H.H.
HUNY. RESIDENCE,
 PROCAVATION COURT NE
 L.J. LINK ST. NW
 PRINCE GEORGE COUNTY
 410.337-9528

**ON-SITE SEWAGE DISPOSAL SYSTEM
HOWARD COUNTY HEALTH DEPARTMENT
BUREAU OF ENVIRONMENTAL HEALTH**

ADDRESS: 3716 Park Overlook PROPERTY OWNER: Hsiung

- SITE PLAN -
 1"=40'-0"

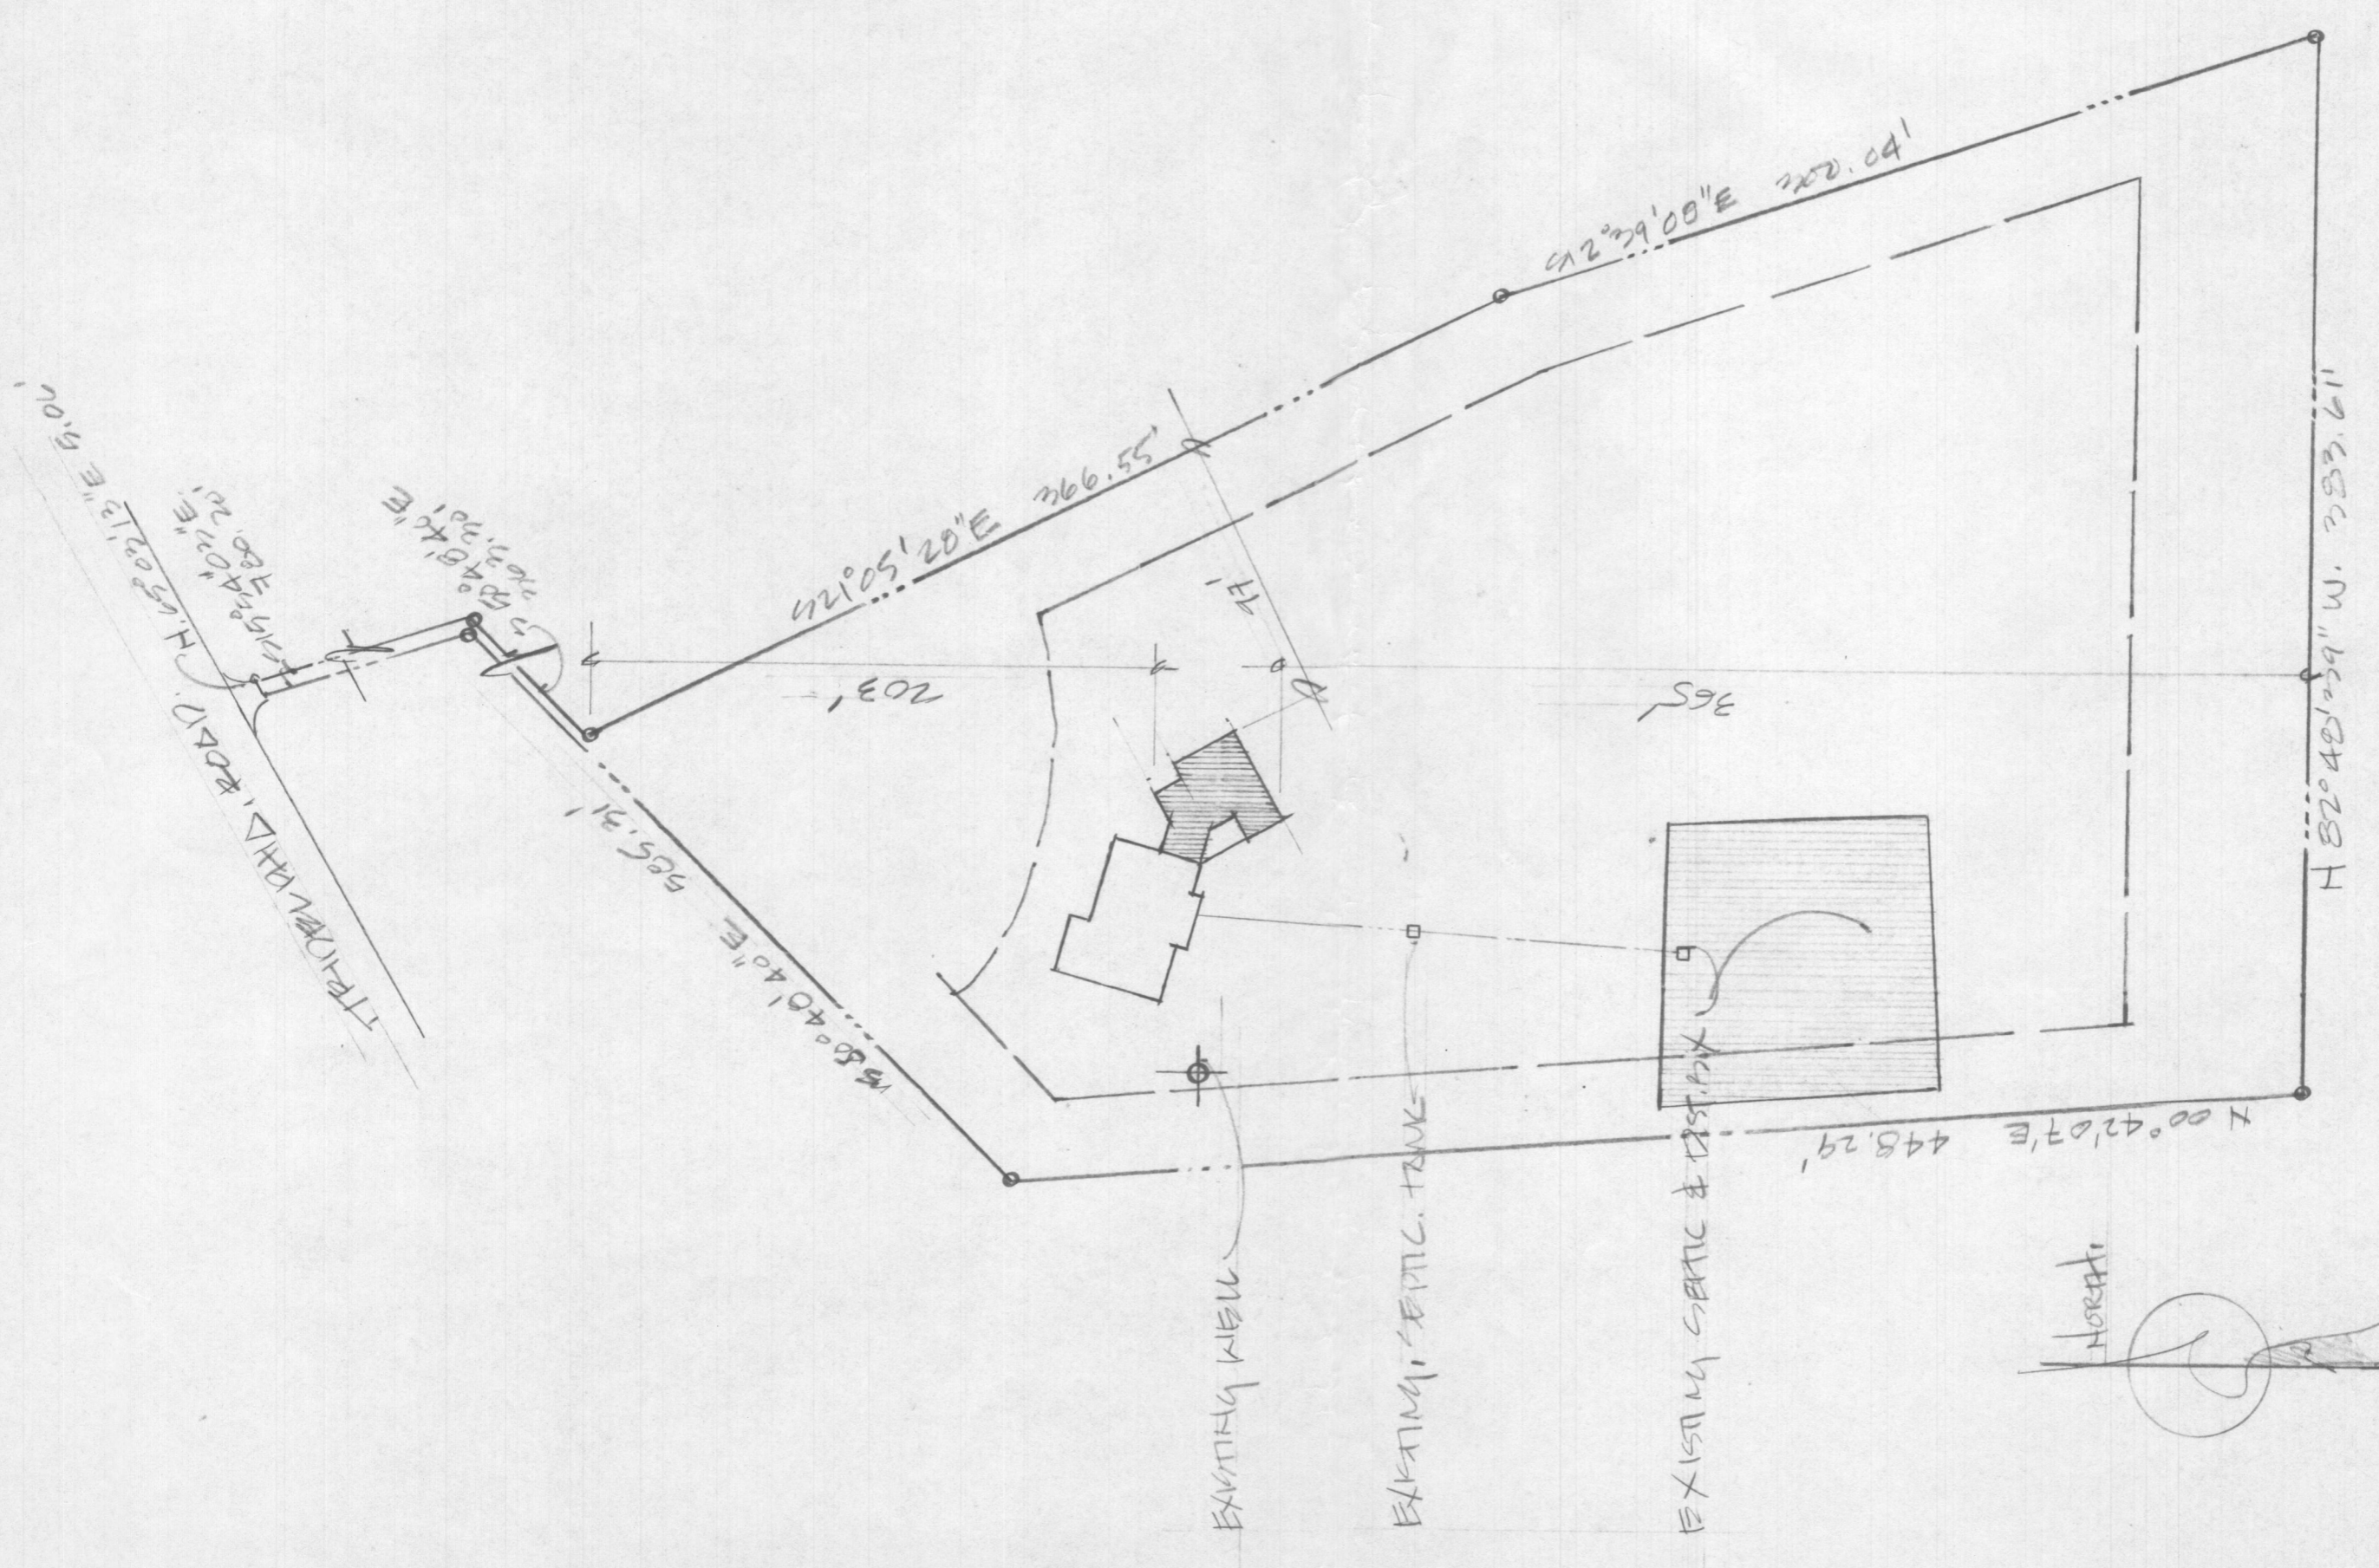
TRENCHES:	Trench to be feet wide. Inlet feet below original grade. Bottom maximum depth feet below original grade. Effective area begins at feet below original grade. feet of stone below distribution pipe.
LOCATION:	
NOTES:	Only a tank replacement needed. If space is available between existing 1250 tank and Dbox, a 1000 gallon tank is acceptable as long as the 1250 meets current code. A layout inspection is required prior to installation.

PRE-CONSTRUCTION 10/31/07 Set new tank near existing tank. Stay 100' from well. Pump out and fill in old tank. (BB)

INSTALLATION 11/2/07 New tank installed. Old tank pumped out and filled in. O.K. to cover. (BB)
